# Final Environmental Impact Report 555 West Middlefield Road

State Clearinghouse #2019070252

# FINAL ENVIRONMENTAL IMPACT REPORT

## 555 WEST MIDDLEFIELD ROAD PROJECT

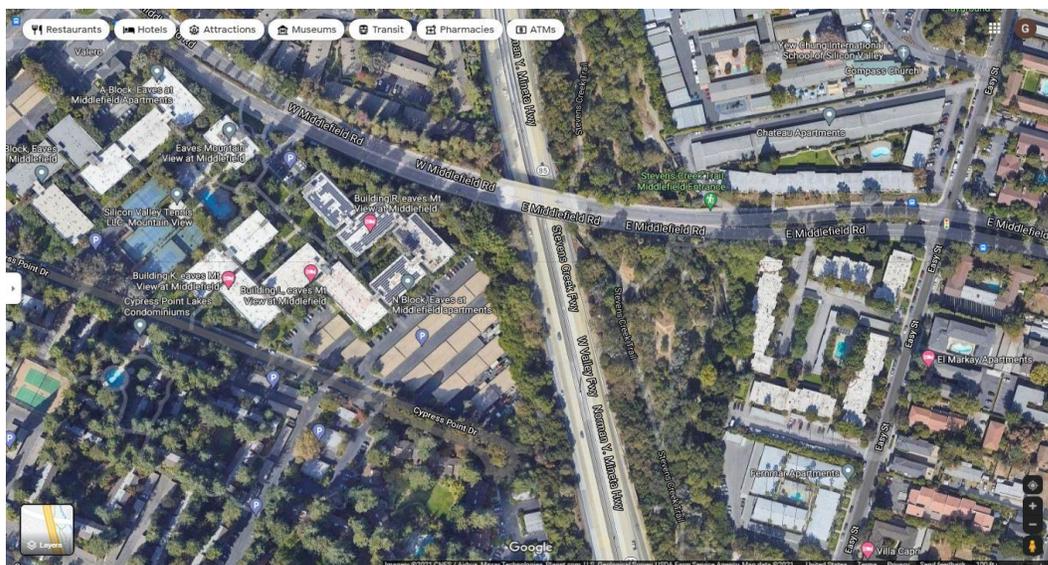
555 Middlefield is proposing to add housing in 3 different locations, using existing surface parking lots to insert additional housing with multi-level underground parking.

Block "C," however, is very problematic as it has serious impacts. The proposed development here involves removal of every single tree in the existing wide tree buffer that currently exists along Hwy 85 and in close proximity to Stevens Creek Trail. This canopy is part of the unique Stevens Creek habitat corridor that extends from the Bay to the hills.

The 80'-100' wide existing urban canopy will be lost to make place for a four-story building near Hwy 85 along with a strip of new landscaping including a few relocated olive trees.

## Comment V.3

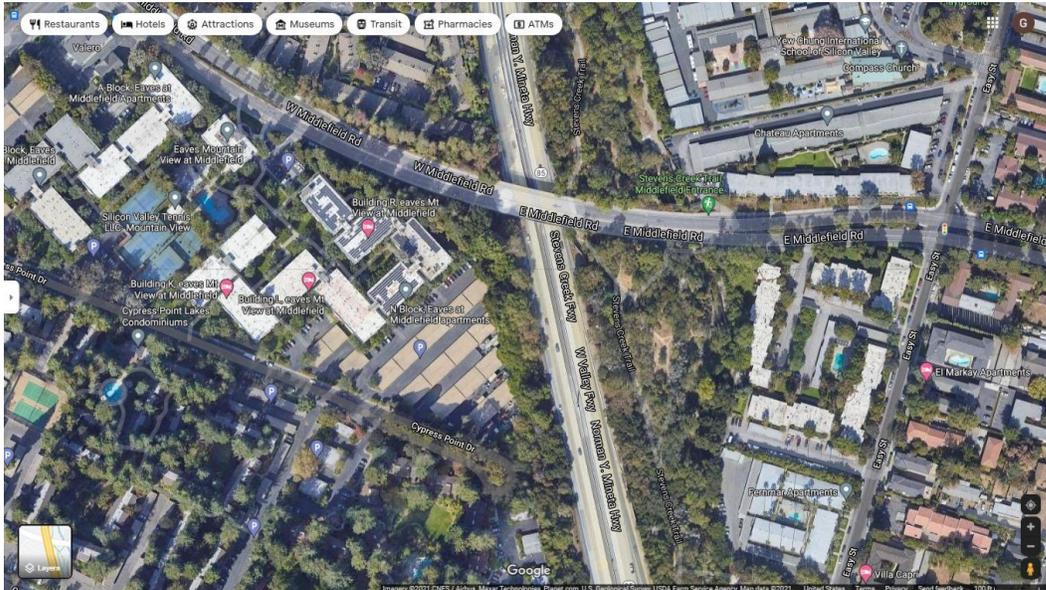
555 Middlefield is proposing to add housing in 3 different locations, using existing surface parking lots to insert additional housing with multi-level underground parking.

Block “C,” however, is very problematic as it has serious impacts. The proposed development here involves removal of every single tree in the existing wide tree buffer that currently exists along Hwy 85 and in close proximity to Stevens Creek Trail. This canopy is part of the unique Stevens Creek habitat corridor that extends from the Bay to the hills.

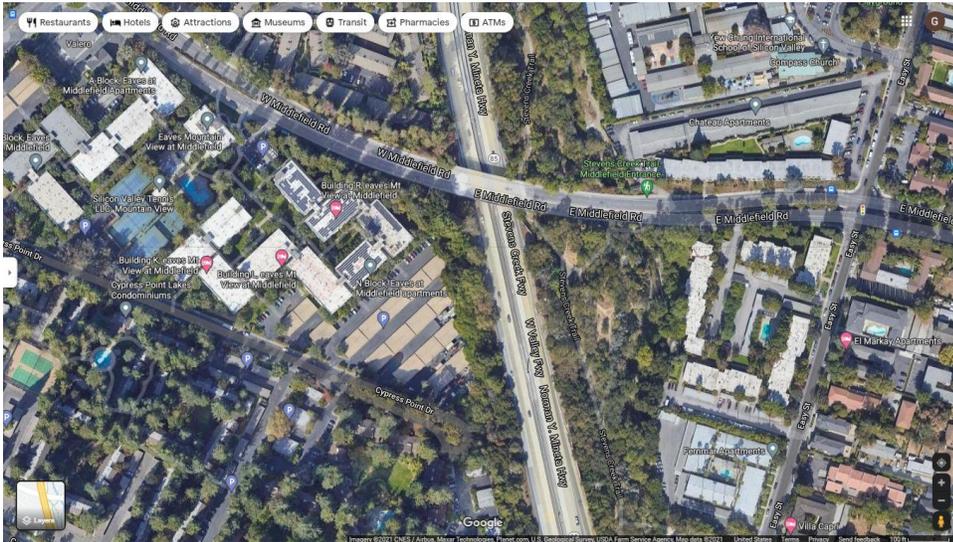
555 Middlefield is proposing to add housing in 3 different locations, using existing surface parking lots to insert additional housing with multi-level underground parking.

Block “C,” however, is very problematic as it has serious impacts. The proposed development here involves removal of every single tree in the existing wide tree buffer that currently exists along Hwy 85 and in close proximity to Stevens Creek Trail. This canopy is part of the unique Stevens Creek habitat corridor that extends from the Bay to the hills.

The 80’-100’ wide existing urban canopy will be lost to make place for a four-story building near Hwy 85 along with a strip of new landscaping including a few relocated olive trees.

We are strongly opposed to degradation of the urban canopy along the habitat corridor and the removal of so many trees. We support the alternative of “No Block C” because we oppose removal of the urban canopy along Hwy 85.

Origin/Destination data for Eaves expansion generated traffic

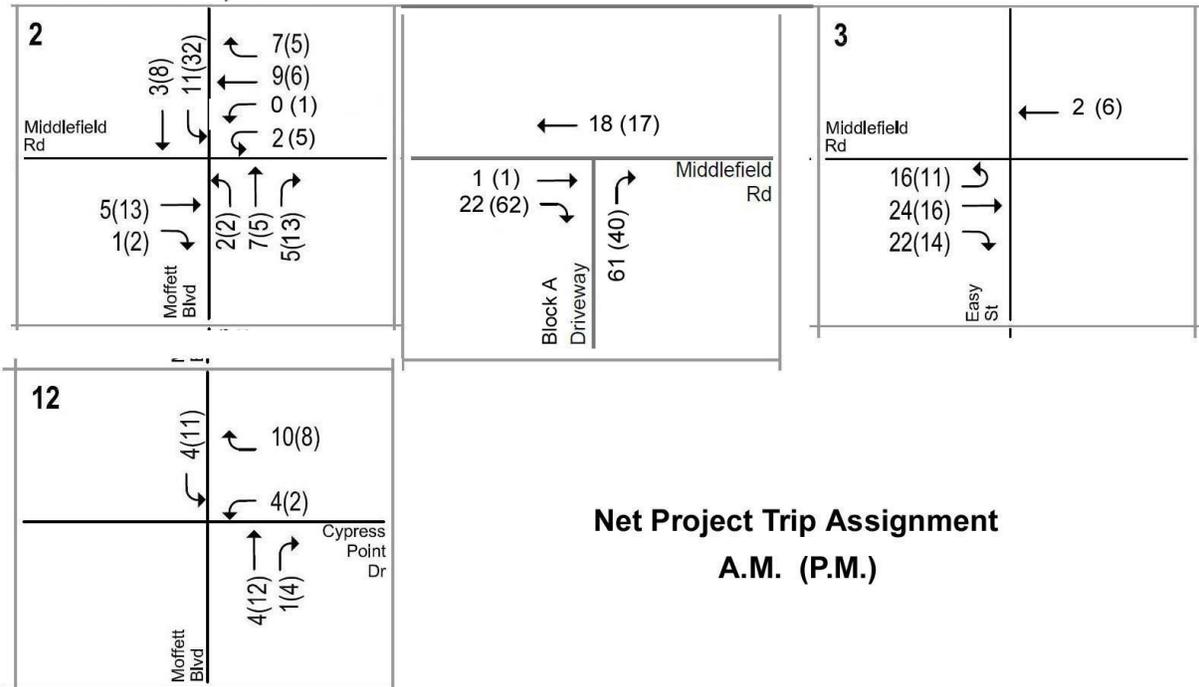
Attachment 2 on page 7 shows an origin/destination matrix for project-generated trips in the immediate vicinity of The Eaves. Thanks to the paucity of information about the trip distribution method, this matrix had to be derived by working backwards from the traffic assignments shown in TIA Figure 9 and the inset to Figure 8, with 2019 trips subtracted from the latter for the sake of consistency. Most notable is that U-turns are minimized in some ways. First, outgoing Block A trips which would have been assigned to southbound Moffett had they originated at Cypress Point are assigned to southbound Easy Street instead. The opposite movement is assigned to eastbound Middlefield or northbound Moffett because left turns from eastbound Central Expressway to Easy Street are prohibited. Second, eastbound trips from Block A are assigned to Middlefield rather than U-turning at Easy Street and taking the freeway. The opposite movement mostly avoids a U-turn at Moffett by being assigned to the freeway, exiting at Moffett and making a left from a supposedly overloaded pocket onto Middlefield.

Data in each cell was derived from movements shown in Figure 9 of the TIA., with the following adjustments to resolve discrepancies in the diagrams; One trip was added to cells marked with an asterisk, and one was subtracted from the cell marked with an ampersand.

The comment compares the trip assignment for the Project in Figure 9 to the data in Table 6 and finds that one additional trip was assigned to the street network in Figure 9. The discrepancy identified by the comment is due to rounding and does not result in any substantive changes to the environmental impact analysis or conclusions in the Draft EIR.

### Figure 2-3: Proposed Site Plan

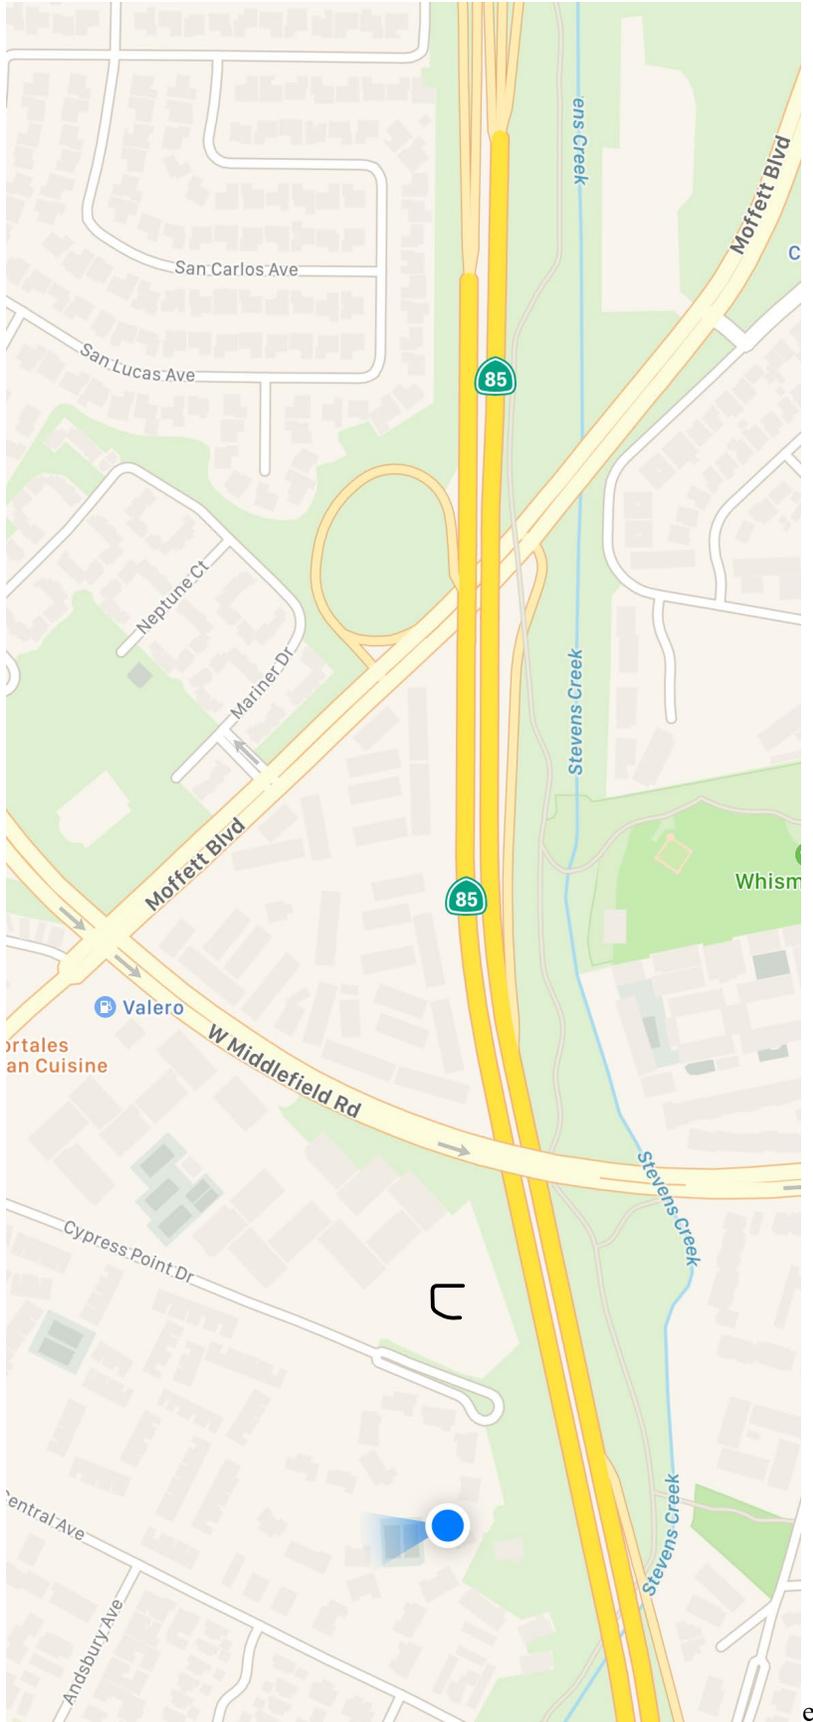
- The diagram labeled figure 2.3 should illustrate the locations of the multi-family housing developments including Cypress Point Woods Townhouses and Cypress Point Lakes Condominiums on the southside of Cypress Point Drive, and Willow Park Apartments on the northside of West Middlefield Road. These are the nearest targets for environmental impacts and should be displayed on all project site diagrams in the DEIR.

- The diagram should also show the proximity of the Stevens Creek Trail Corridor to Block C. I will attach a Google Map on page 8 that displays the proximity of this very important feature of Mountain View. The map displays the Stevens Creek Trail Corridor in green. The surface parking lot in Block C is marked with a “C” and is located at the end of Cypress Point Drive. The woodland area in Block C is visible as a green area to the north and east of Block C.

- A new diagram is needed. It is very important to illustrate the footprint of the new apartment building and underground garage in Block C. This footprint would be overlaid by the existing location of the trees including Heritage trees that AvalonBay plans to cut

down and remove to construct the apartment building, underground garage, and the emergency vehicle access road. Without this diagrammatic overlay it is not possible to fully assess the environmental impacts in Block C and surrounding lands.

The comment requests that the Figure 2-3, *Proposed Site Plan*, from the Draft EIR be revised to include surrounding land uses. Figure 2-3 is provided in Chapter 2, *Project Description*, of the Draft EIR for purposes of providing a depiction of the proposed site plan, not surrounding land uses. Figure 2-2, *Project site*, on page 2-5 of the Draft EIR provides the location of the Project site within the larger City of Mountain View context, which includes those uses listed in the comment above. In addition, Figure 3.1-1 in Section 3.1, *Aesthetics*, provides images of the existing conditions in the vicinity of the Project site.

Figure 2-3: Proposed Site Plan

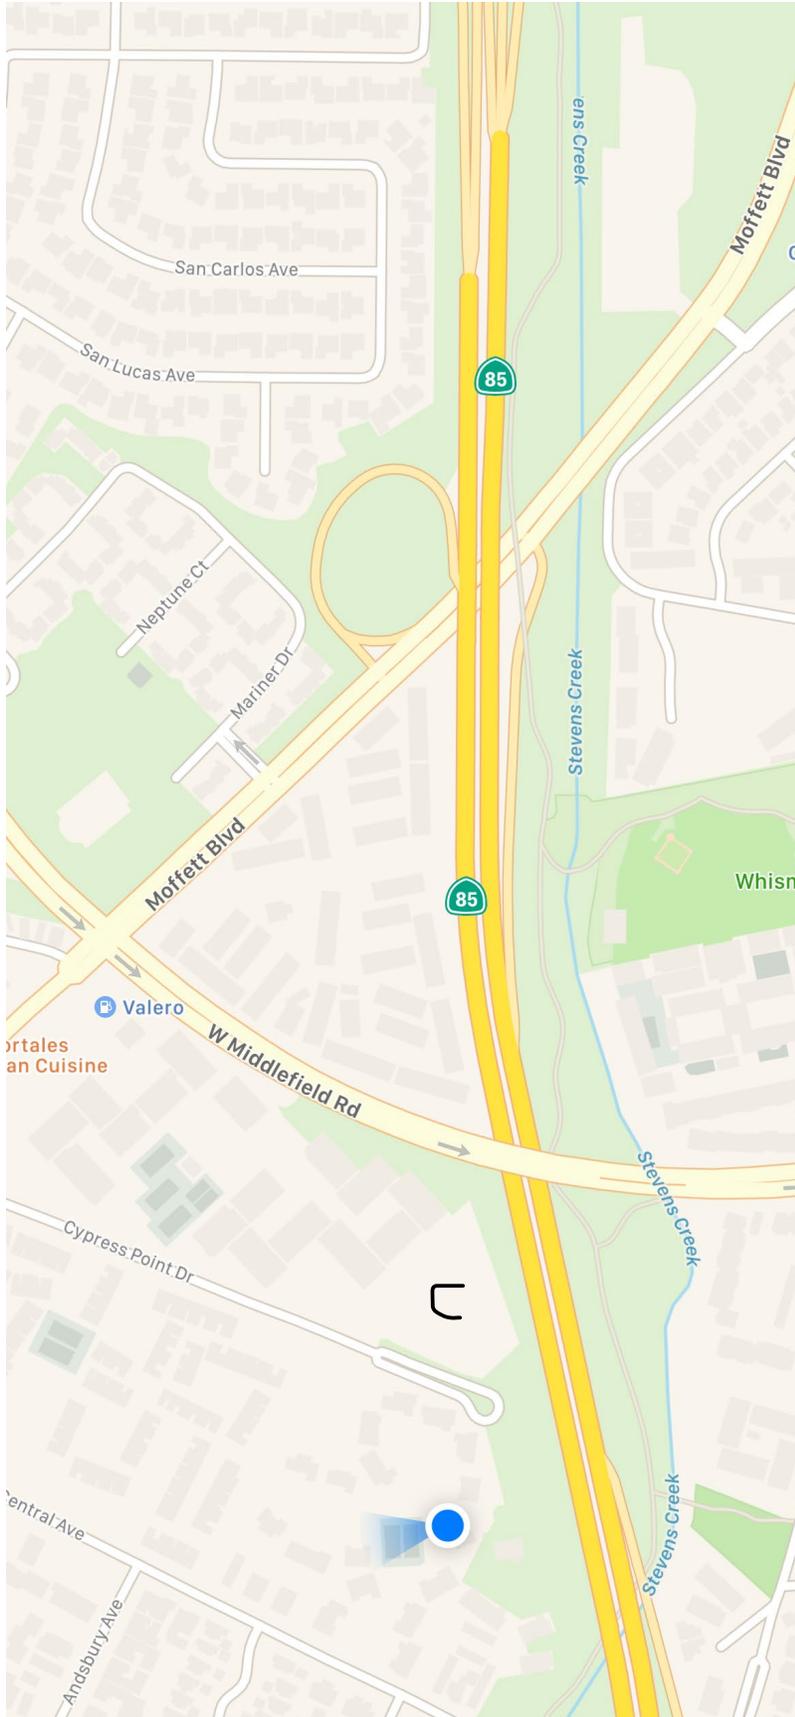
- Another diagram is needed and very important to illustrate the footprint of the new apartment building and underground garage in Block C. This footprint would be overlaid by the existing location of the trees including Heritage trees that AvalonBay plans to cut down and remove to construct the apartment building, underground garage, and the emergency vehicle access road. Without this diagrammatic overlay it is not possible to fully assess the environmental impacts in Block C and surrounding lands.

Refer to the response to comment N.25, above. Figure 2-3 is provided in Chapter 2, *Project Description*, of the Draft EIR for purposes of providing a depiction of the proposed site plan, not surrounding land uses. Figure 2-2, *Project site*, provides the location of the Project site within the larger City of Mountain View, which includes those uses listed in the comment above. In addition, Figure 3.1-1 in Section 3.1, *Aesthetics*, provides images of the existing conditions in the vicinity of the Project site.

V.3

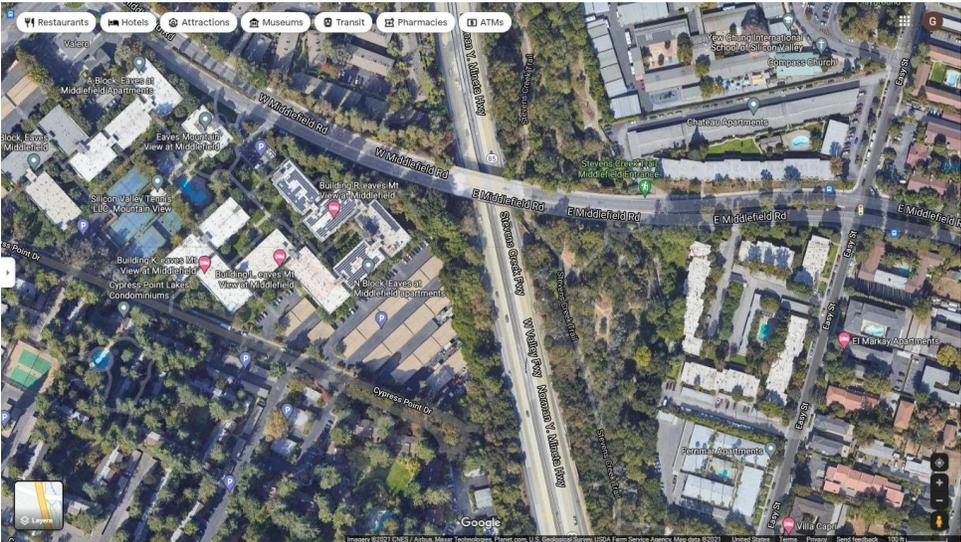
Block “C,” however, is very problematic as it has serious impacts. The proposed development here involves removal of every single tree in the existing wide tree buffer that currently exists along Hwy 85 and in close proximity to Stevens Creek Trail. This canopy is part of the unique Stevens Creek habitat corridor that extends from the Bay to the hills.

The 80’-100’ wide existing urban canopy will be lost to make place for a four-story building near Hwy 85 along with a strip of new landscaping including a few relocated olive trees.

We are strongly opposed to degradation of the urban canopy along the habitat corridor and the removal of so many trees. We support the alternative of “No Block C” because we oppose removal of the urban canopy along Hwy 85.
